Coalpac

15th July 2014

Response to NSW Office of Environment and Heritage (OEH) Review of Biodiversity Impacts for Coalpac Expansion Modifications

Figure 1 – Indicative Distribution of the Broad-headed Snake (Source OEH website, Broad-headed Snake Profile)

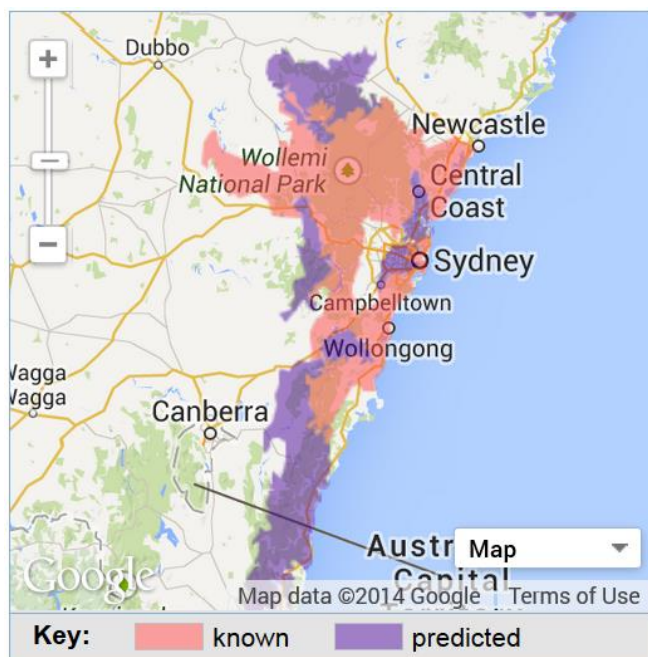
OEH have raised a number of concerns regarding the approach taken in the treatment of the Broad-headed Snake (BHS) in the RTS.

The indicative known habitat for the BHS in NSW is approximately 2.5 million ha based on information on the OEH website, Broad-headed Snake Profile, see Figure 1. The total disturbance area for proposed for the Modifications is 151 ha which represents 0.00006% of the indicative known BHS habitat in NSW.
